**POTENTIAL EXPLORATION, DEVELOPMENT, AND PRODUCTION OF
OIL AND GAS RESOURCES; VANDENBERG AIR FORCE BASE, CALIFORNIA**

FINAL ENVIRONMENTAL IMPACT STATEMENT

The final EIS relies upon the analyses provided in the draft EIS. It does not repeat draft EIS information. It provides erratas for the EIS, Air Quality Technical Appendix, and MRMP. In addition, public and written comments on the draft EIS and responses are provided.

Figure 3.2-1A
WATER WELL LOCATIONS

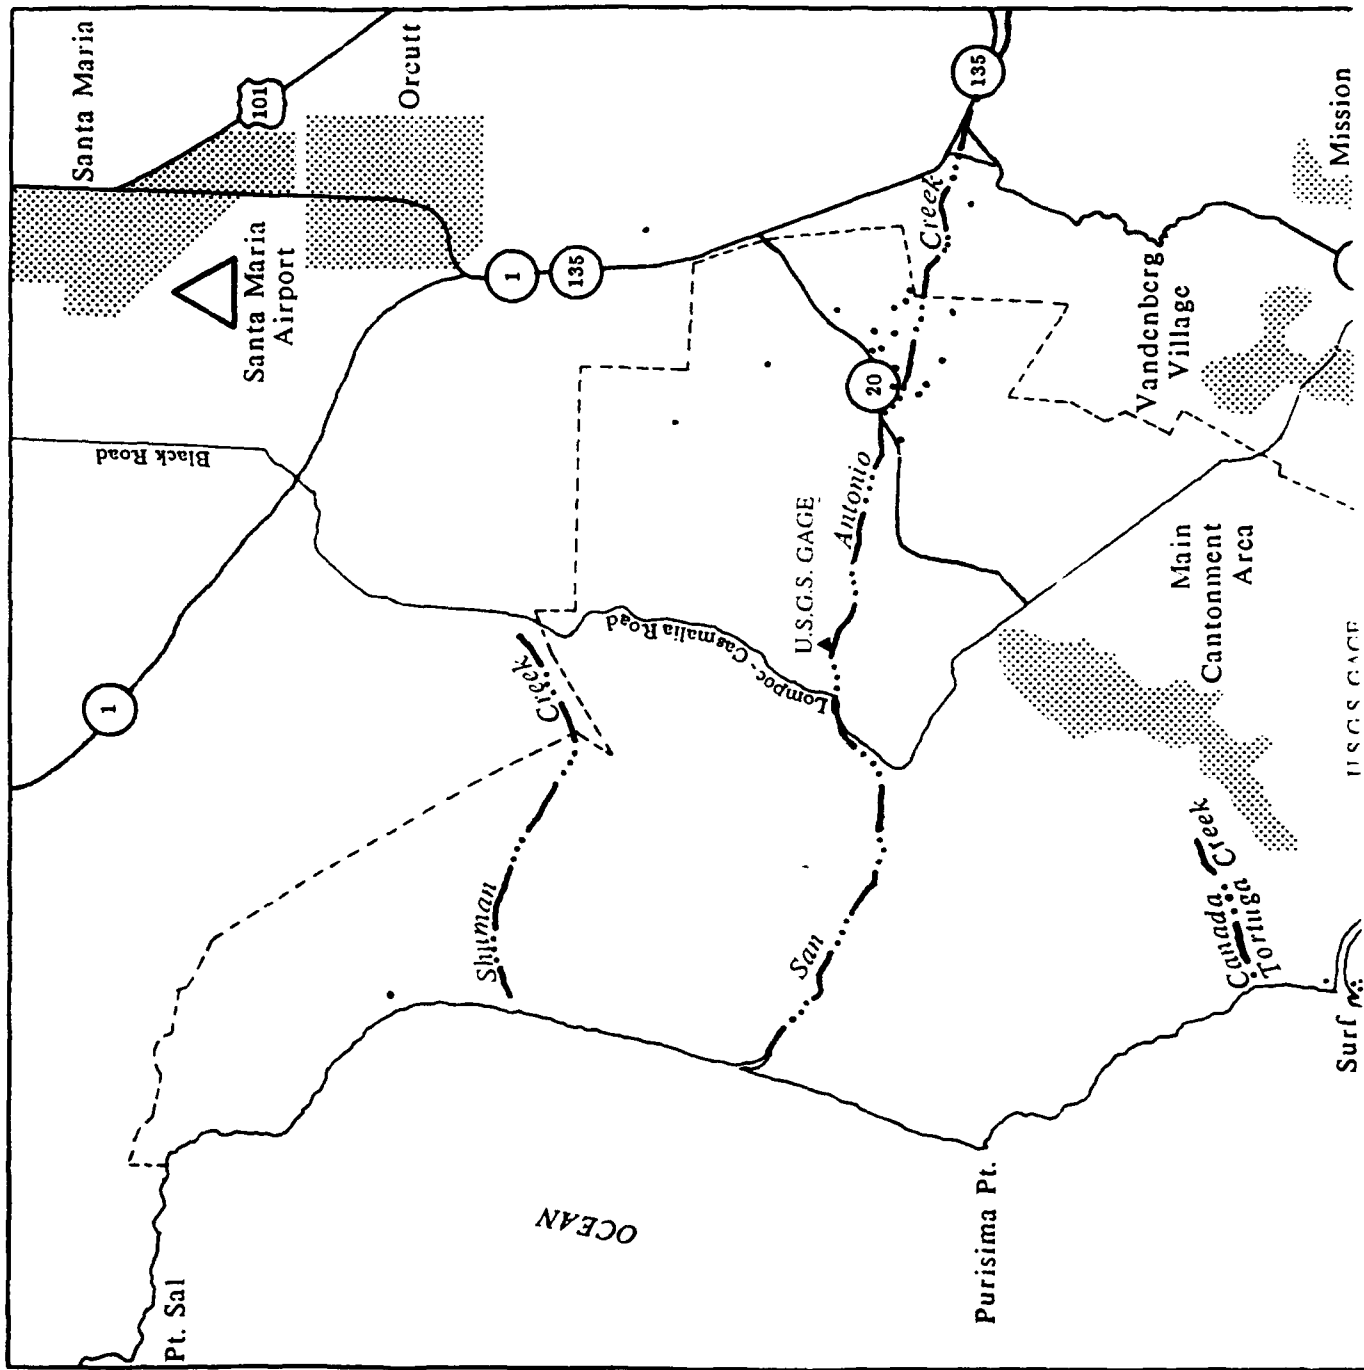
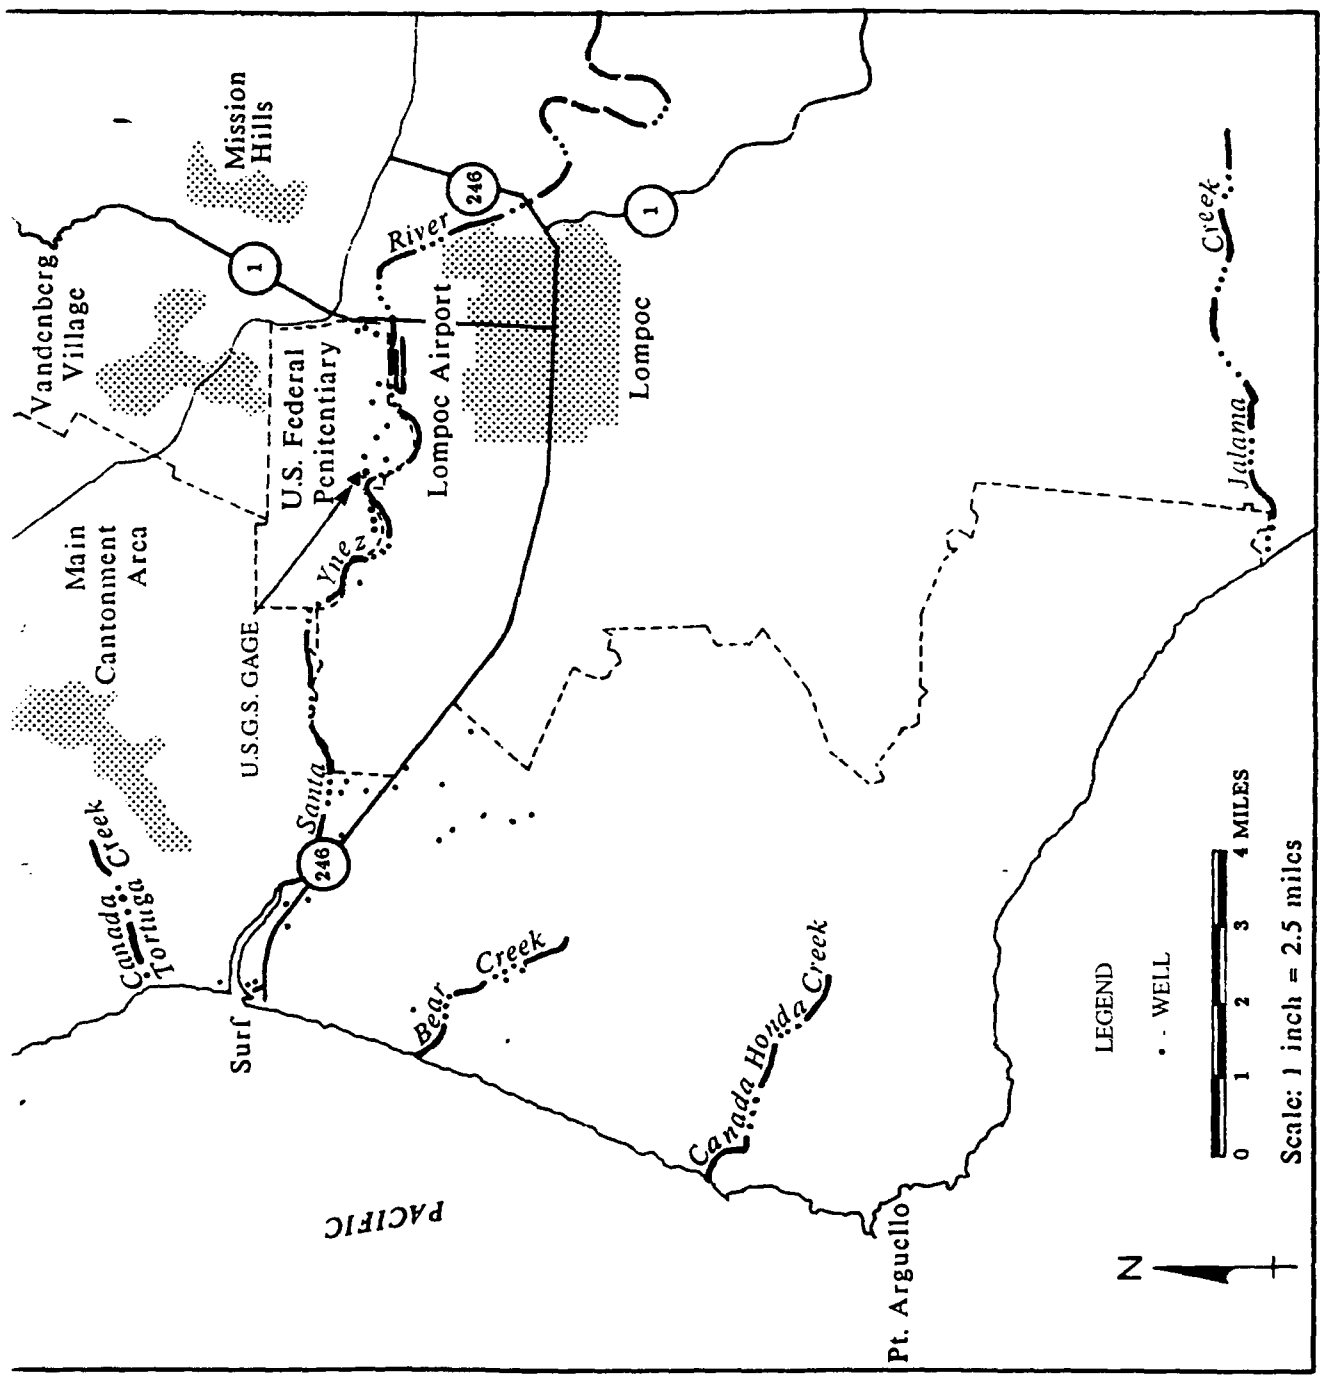
Section 3.2.4.1.2; page 3.2-8, add the following sentence at the end of paragraph one: "Water well locations are shown in Figure 3.2-1A." See the attached figure.

WQCB-5 Surface water and groundwater features are delineated in figures 3.2-1 and 3.2-2 of the DEIS, respectively. Water well locations are displayed on a new figure (Figure 3.2-1A of the errata for the EIS).

Figure 3.3-2
SANTA BARBARA COUNTY AIR QUALITY
MANAGEMENT REGION

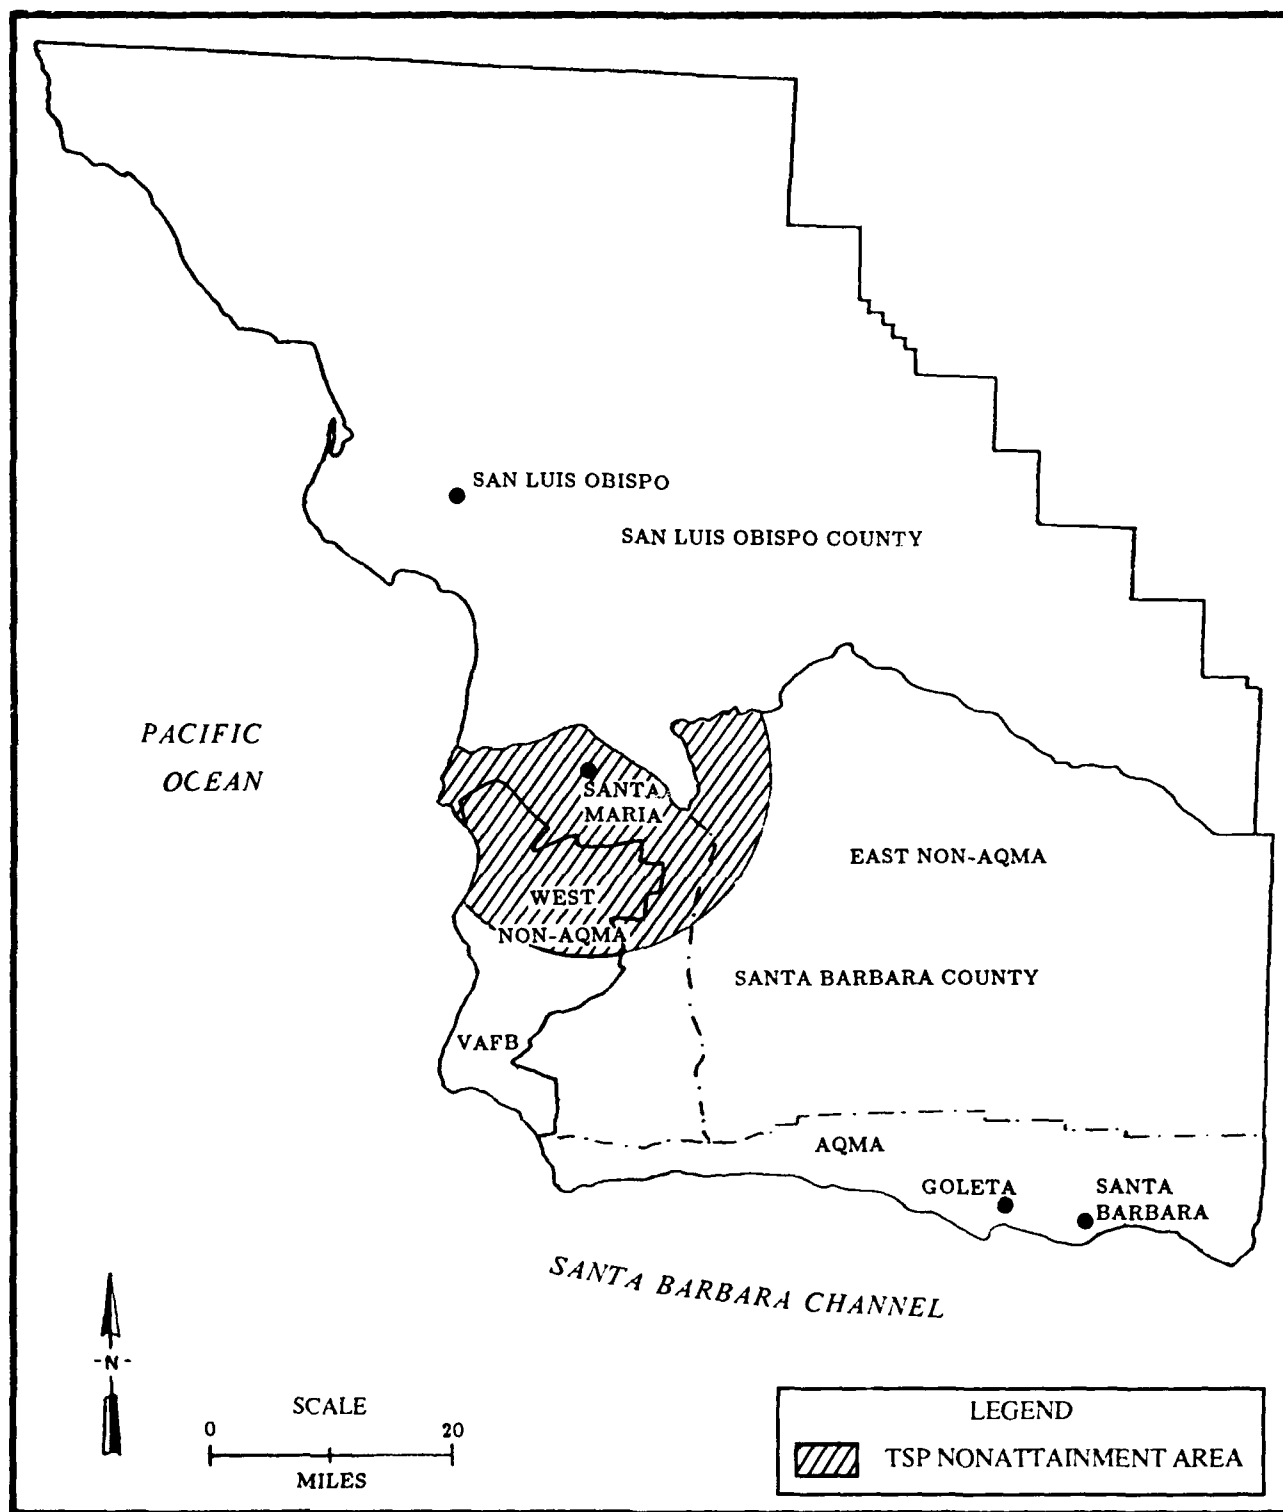
Page 3.3-9, the TSP nonattainment area in Figure 3.3-2 has been corrected to only include the 15-mile radius from Santa Maria that is within Santa Barbara County.

1. The TSP non-attainment area described on page 3.3-7 and depicted in Figure 3.3-2 mistakenly includes a portion of southern San Luis Obispo County. No areas in San Luis Obispo County are currently designated as Federal non-attainment areas for any pollutants. TSP measurements at Nipomo are well within Federal standards. The Nipomo monitoring station is located approximately nine miles north of Santa Maria. This correction should be noted in the FEIS.

Figure 3.3-3
AIR QUALITY MONITORING STATIONS

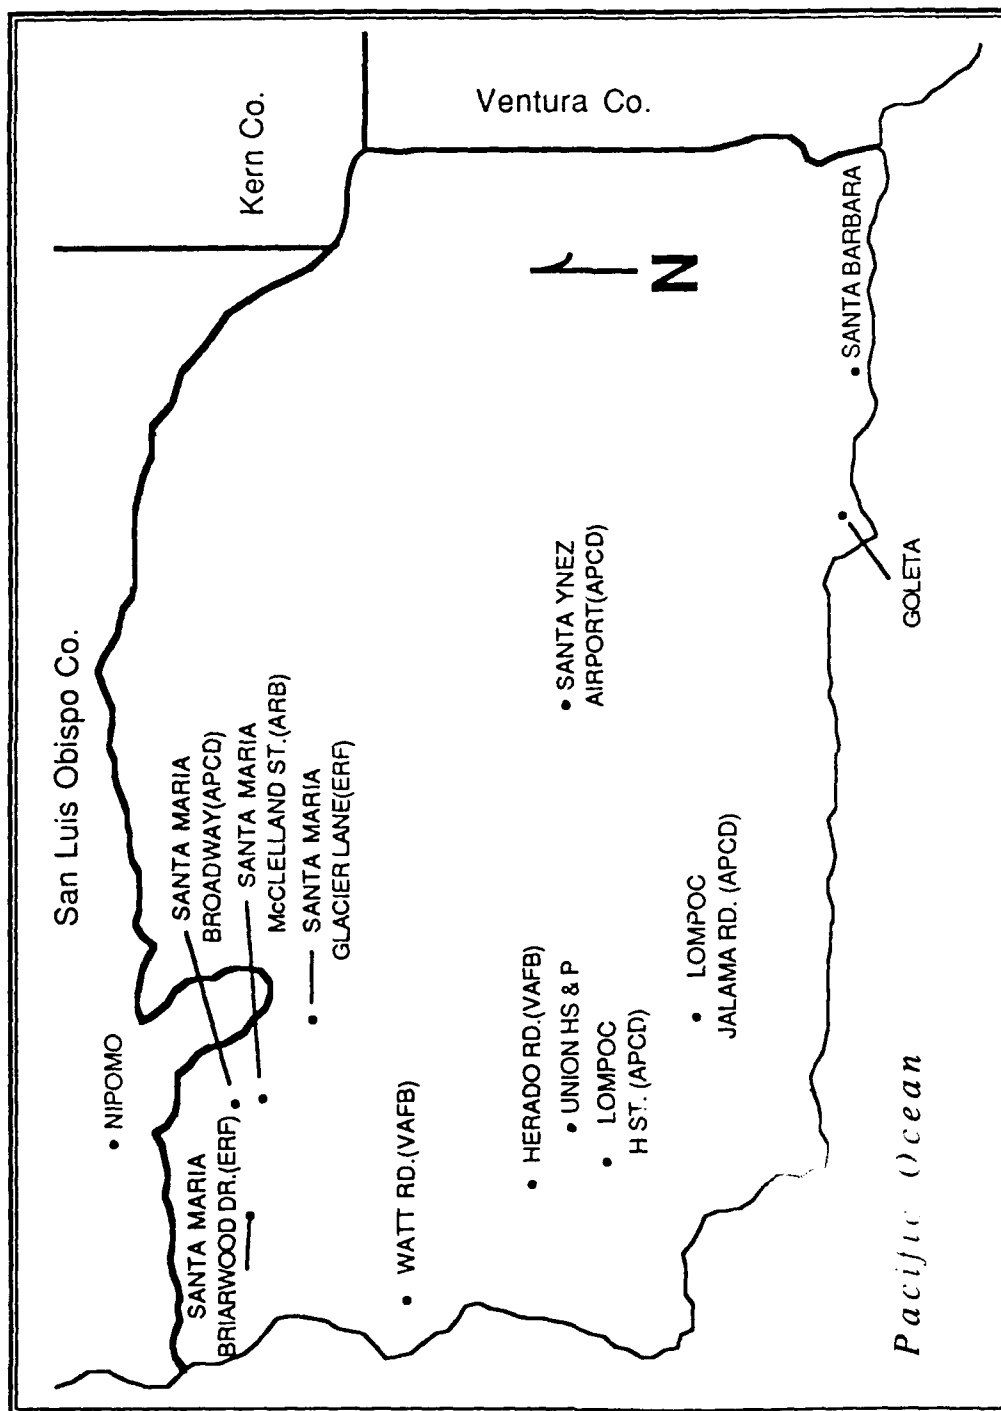
Page 3.3-11, Figure 3.3-3 has been changed to include the Nipomo monitoring station in San Luis Obispo County. See the attached figure.

Figure 3.8-1
PRINCIPAL TRANSPORTATION ACCESS TO VAFB

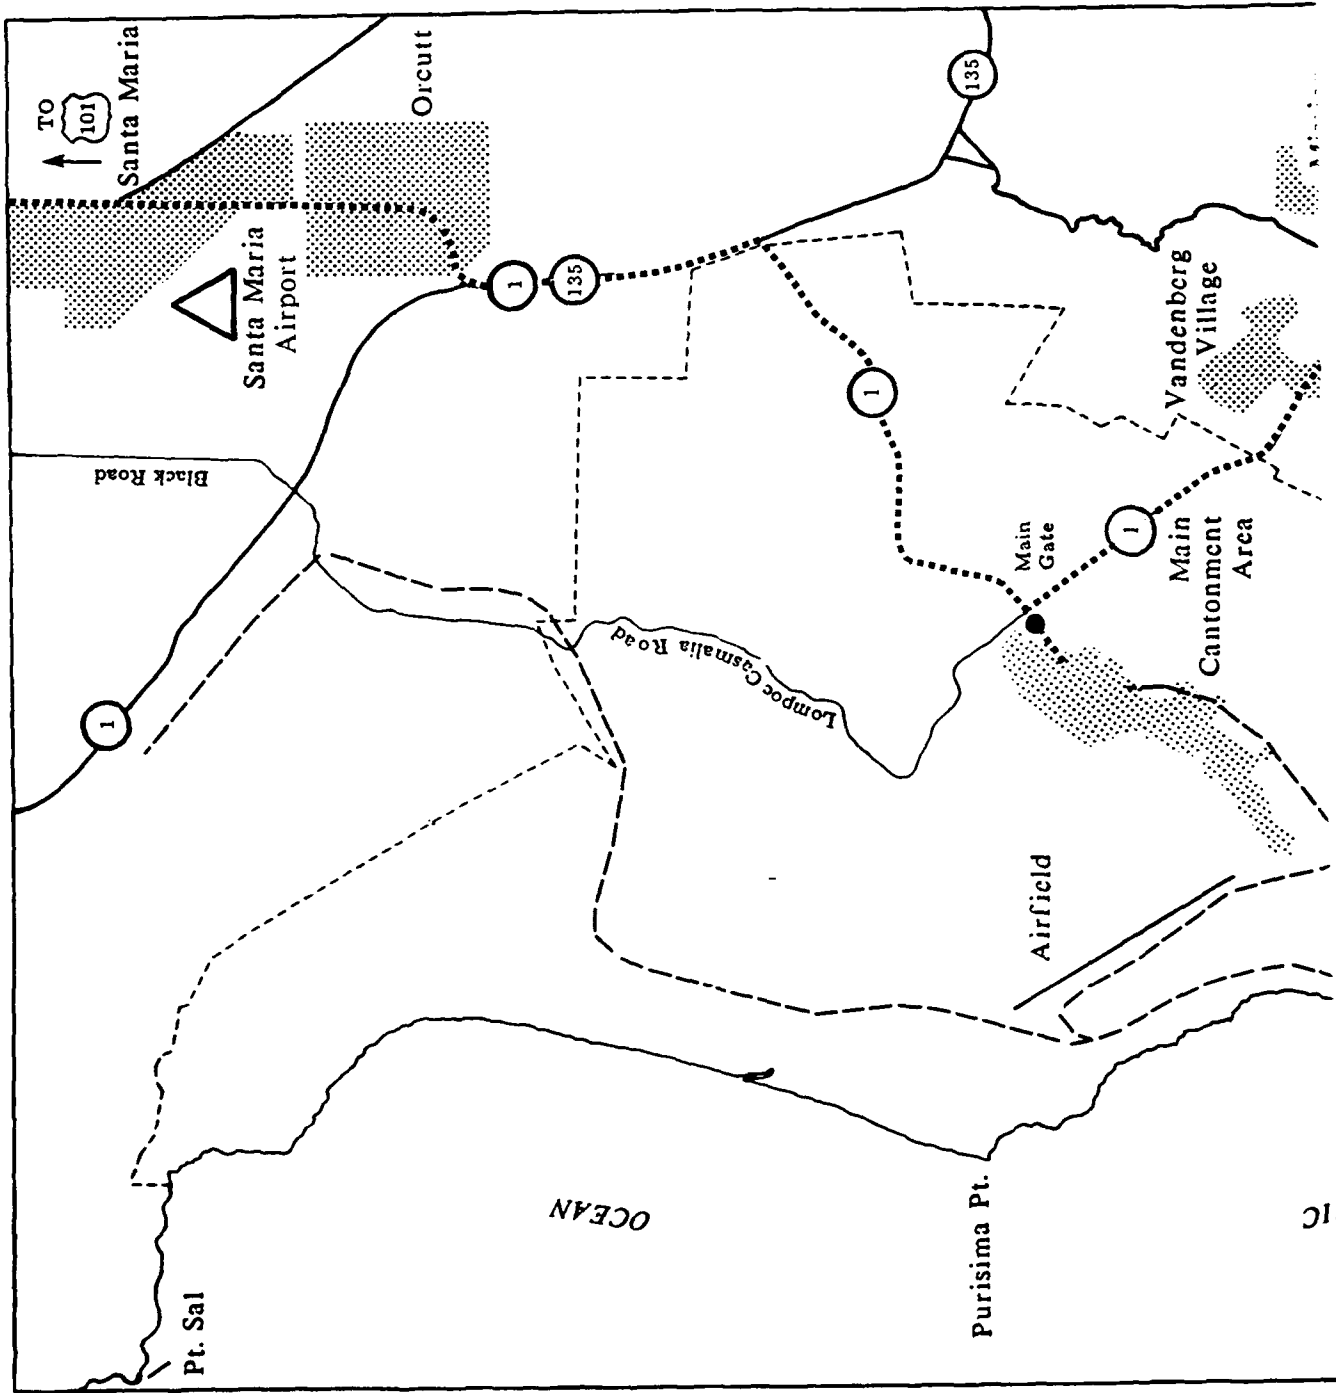
Figure 3.8-1 on page 3.8-3 has been revised. Please see the attached figure.

The maps showing Route 101 intersecting Route 135 in Santa Maria (fig. 3.8-1, 3.8-2, & 4.8-1) are in error. The intersection takes place to the north of this location. What is shown is Santa Maria Way - not Route 101. Also, County Road S20 is now State Route 1 through Vandenburg AFB. The old Route 1, between Lompoc and Route 135, has been relinquished to the county.

Figure 4.9-3
STEAM GENERATOR

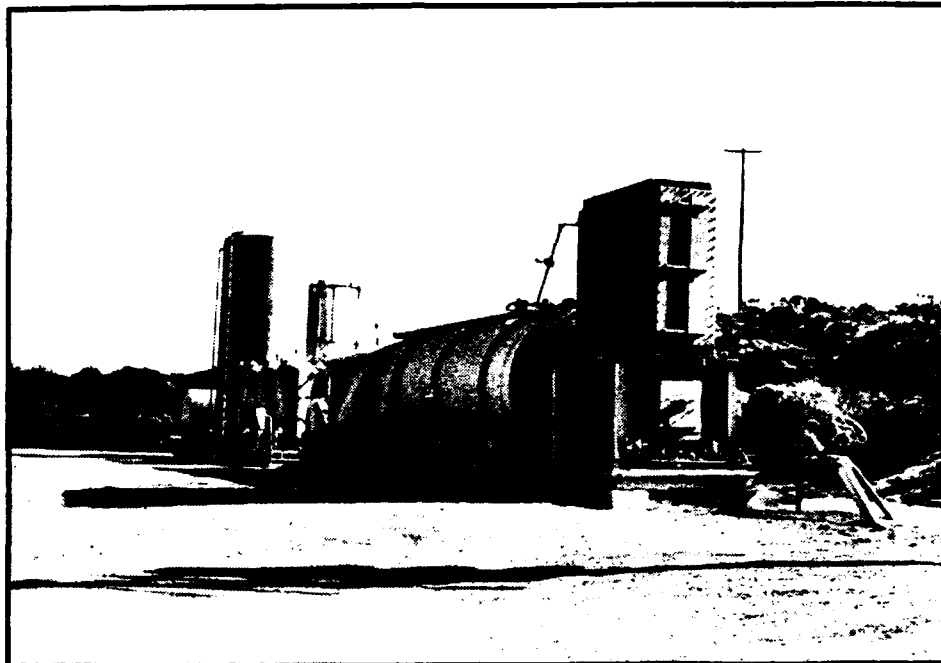
Figure 4.9-3 on page 4.9-5 has been retitled "Steam Generator" as shown on the attached figure.

Figure 4.9-3 is incorrectly titled "H₂S Scrubber". This photograph actually depicts a steam generator.
